**CONTRACT ADDENDUM #**

**date:** 5.10.24  
**project:** Nibley Middle School  
**by:** Michael Rigby  
**subject:** Addendum 02

Clarification and changes from Bid Package 1 to Bid Package 2. Includes update to the concrete openings, structural items – see structural narrative, and civil items – see civil narrative.

**SUBJECT:** Addendum #2 – Changes to Bid Package #1

CIVIL - ROADWAY  
 PLAN & PROFILE  
 3020 S / 920 W

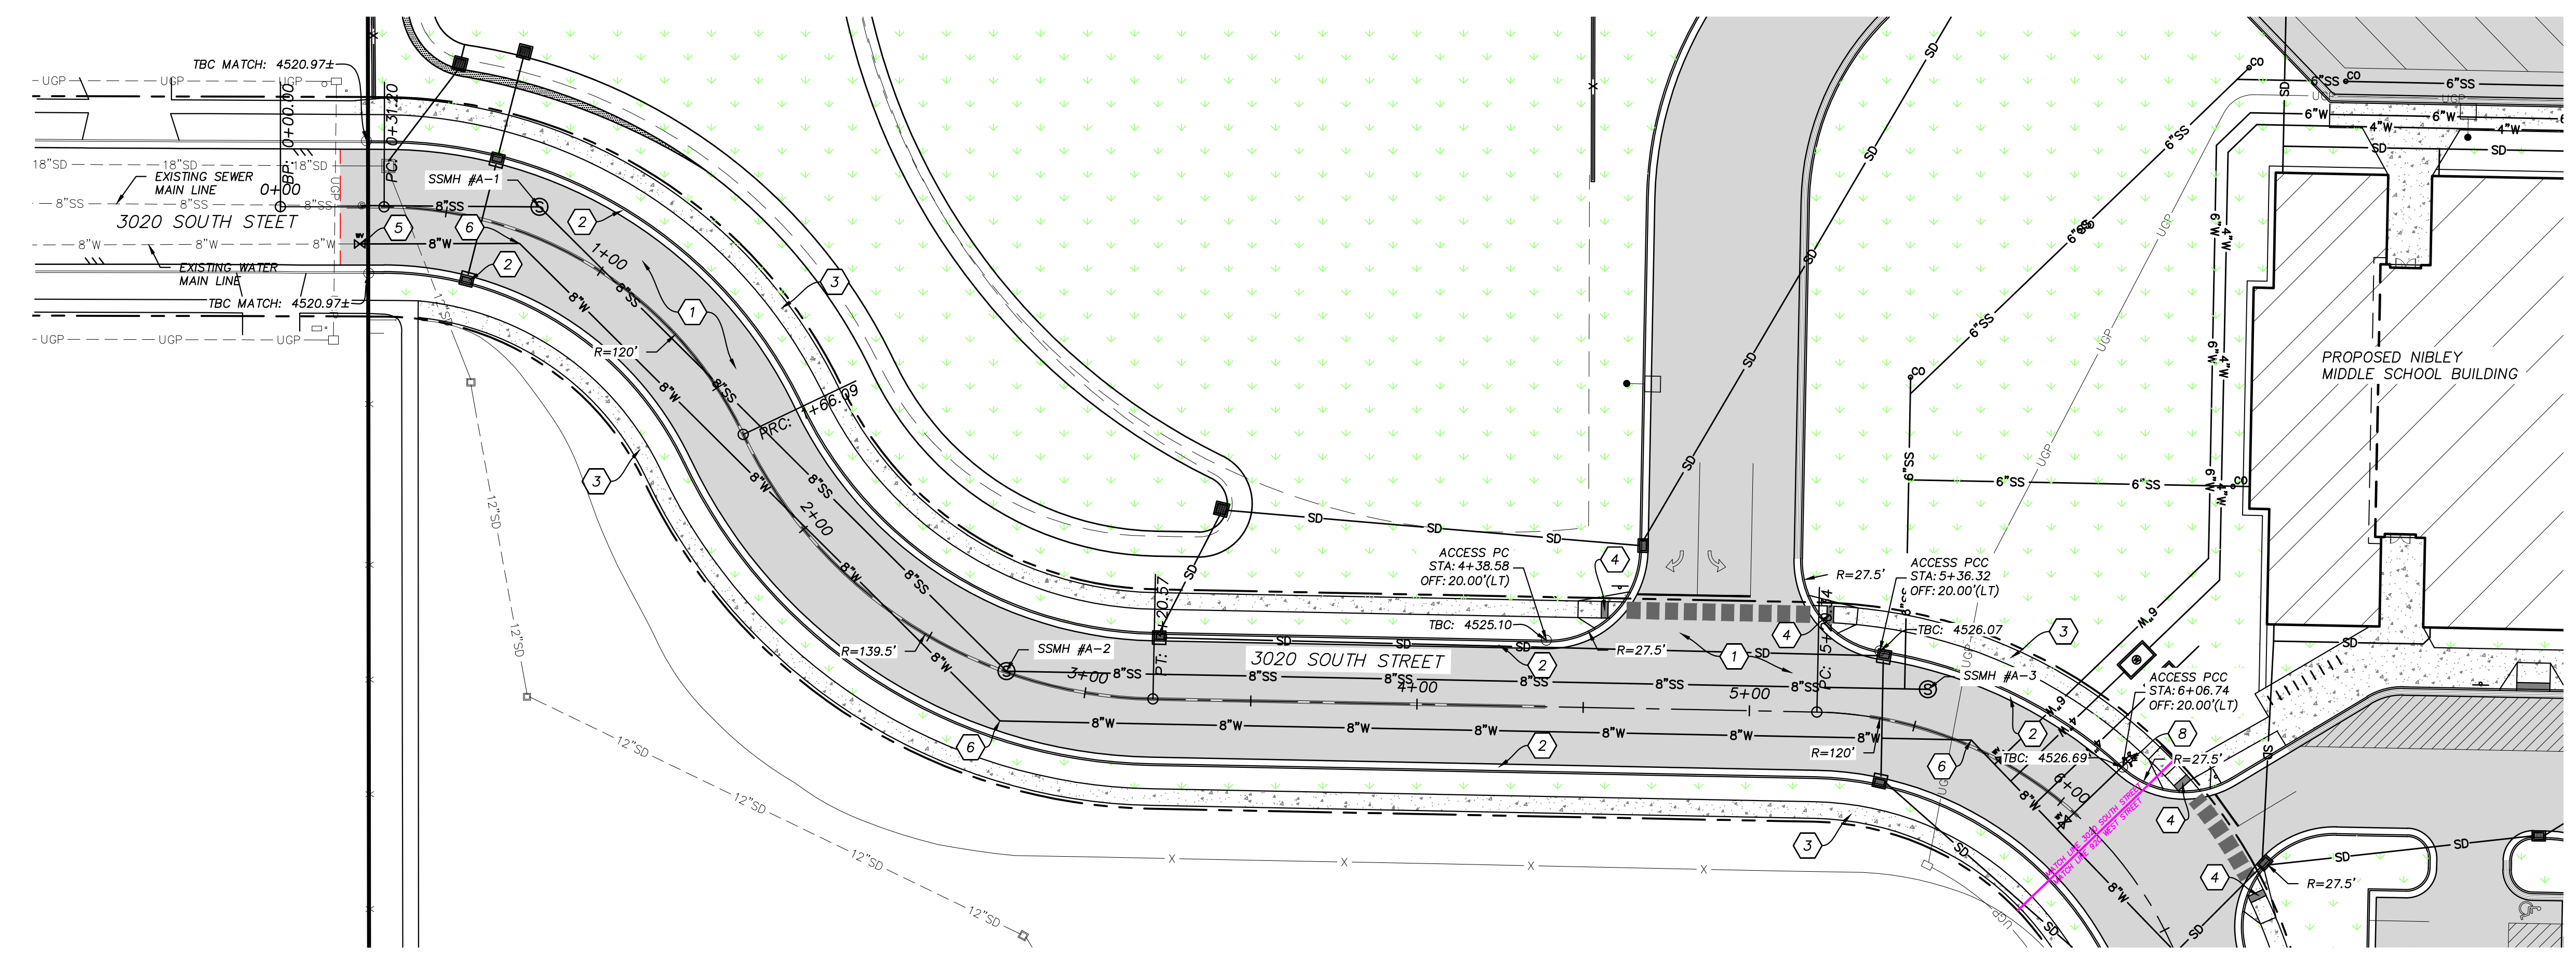
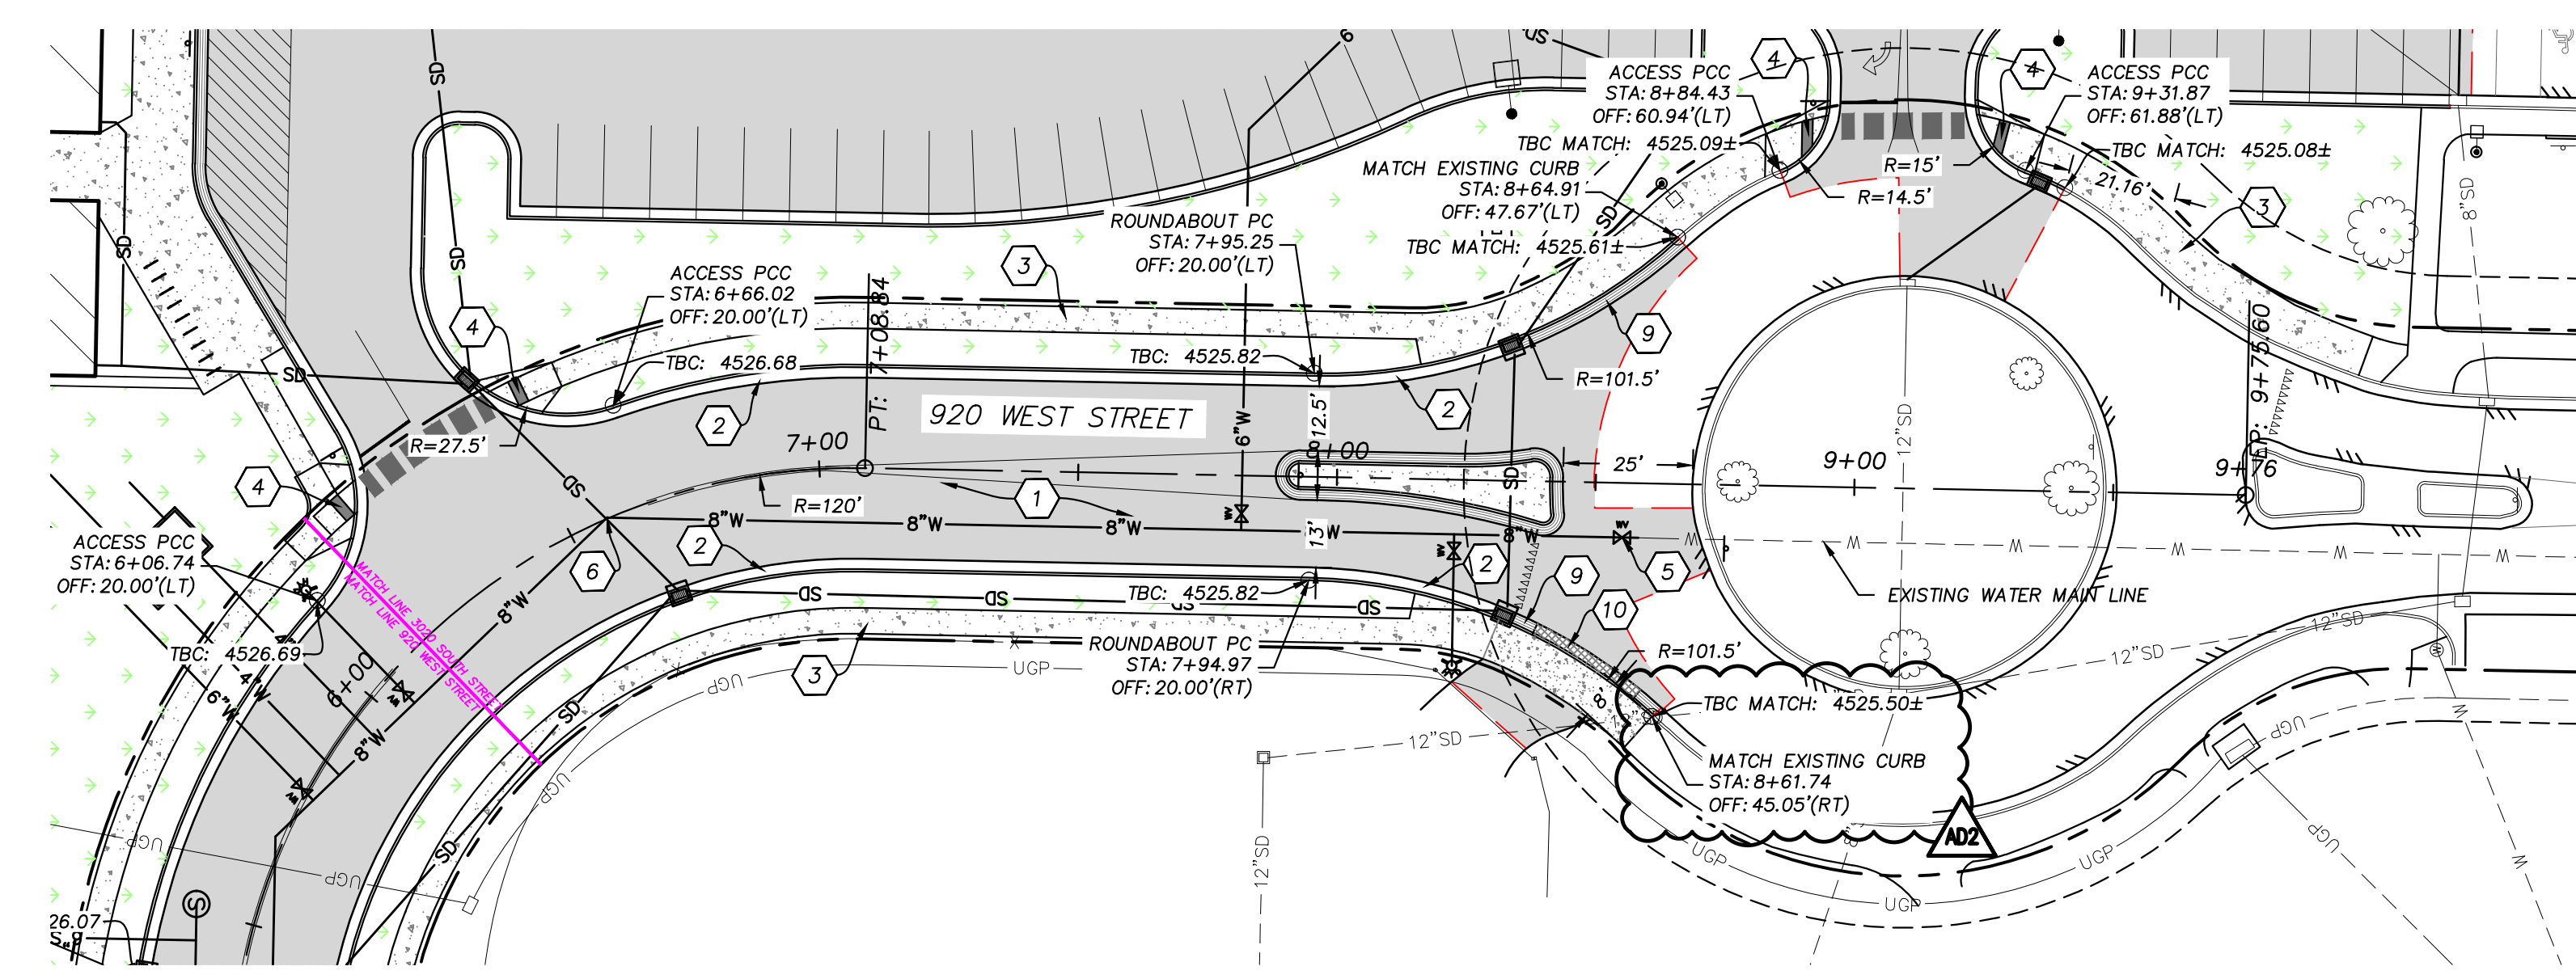
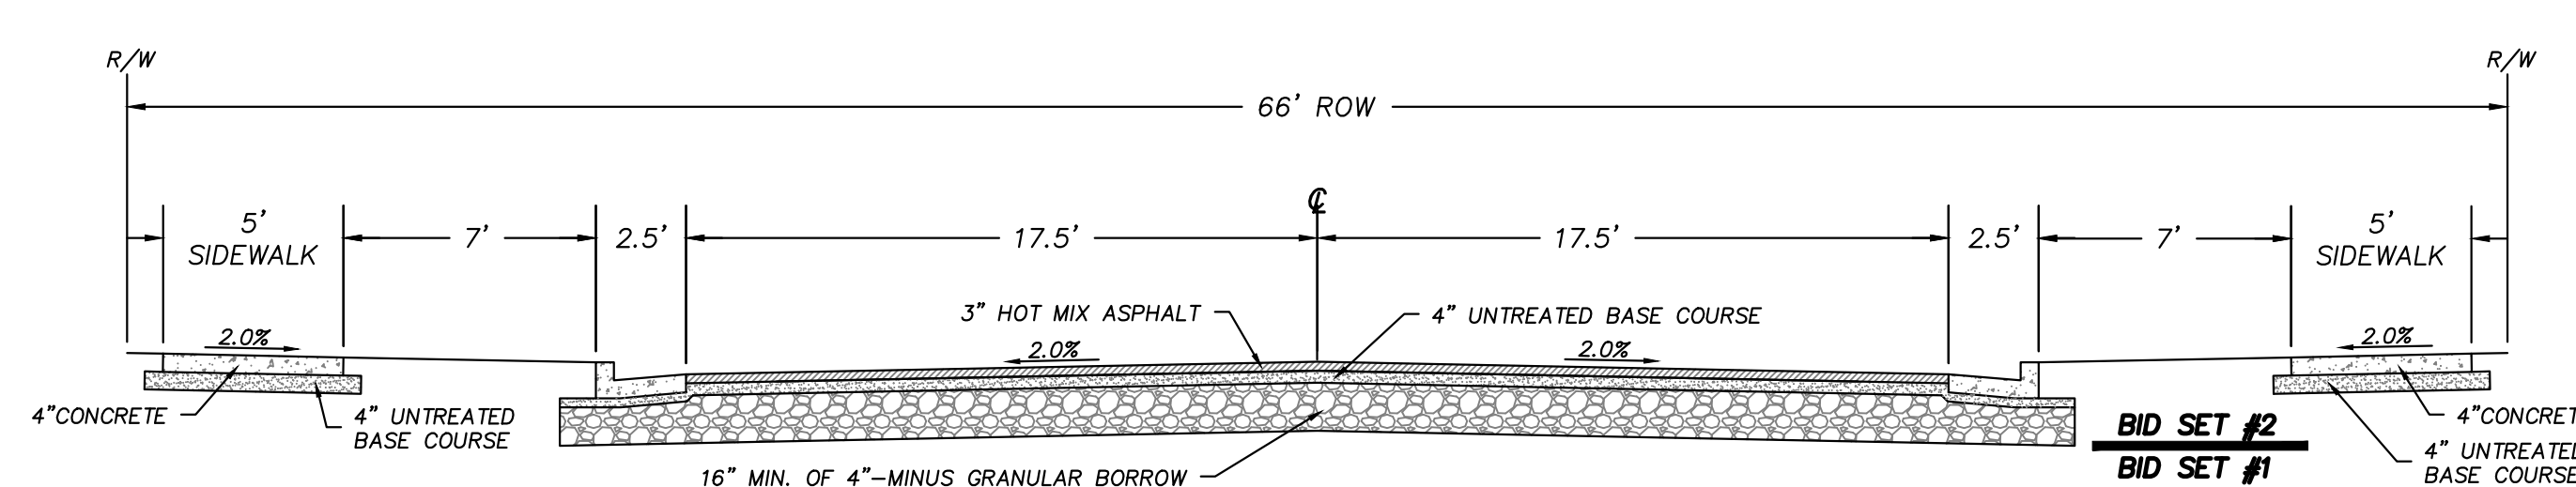
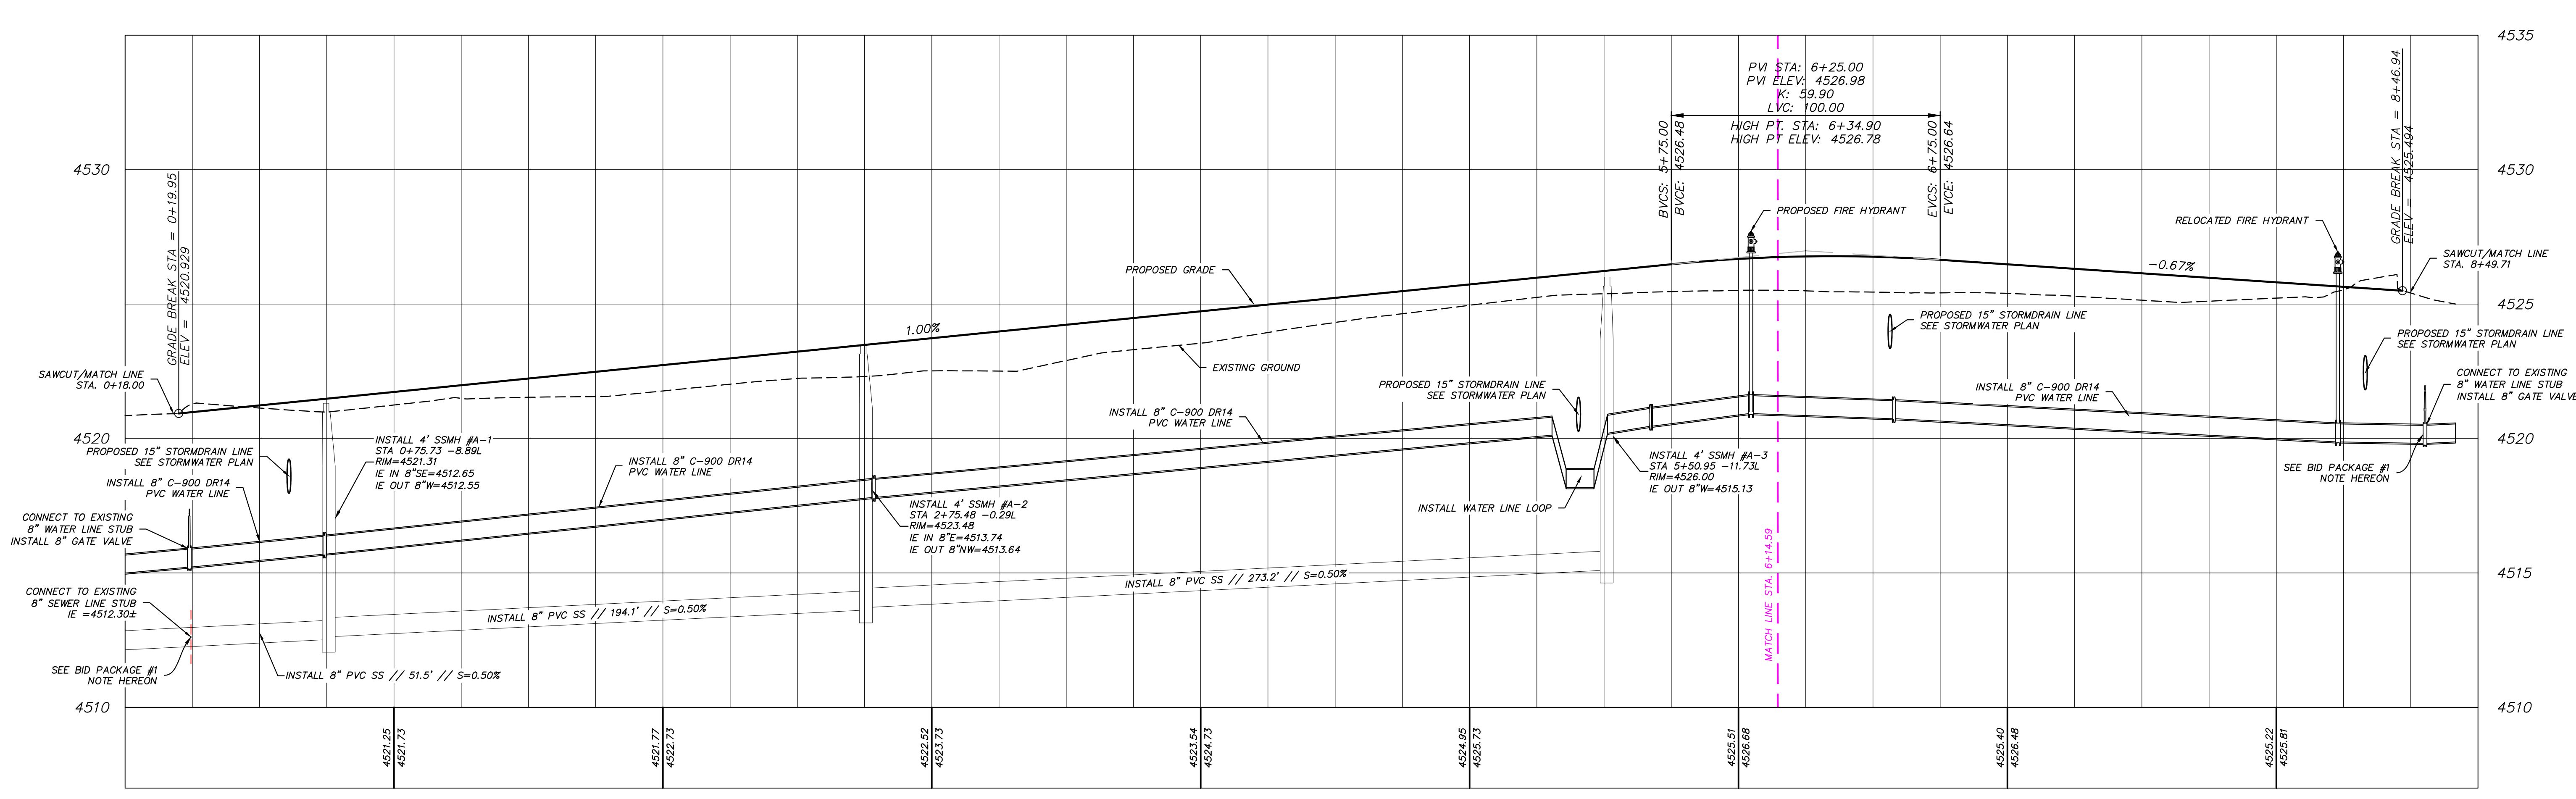
1. **Civil – Roadway Plan & Profile – 3020 S / 920 West, Sheet C-601.**
  - a. **CHANGED** – Elevation for TBC match at northwest area of roundabout based on elevation adjustments made for control points.
  - b. **CHANGED** – Elevations for Roundabout Island based on change to TBC match point.  
(These elevation changes have already been included in the files sent to SUNROC for use in creating their GPS models)
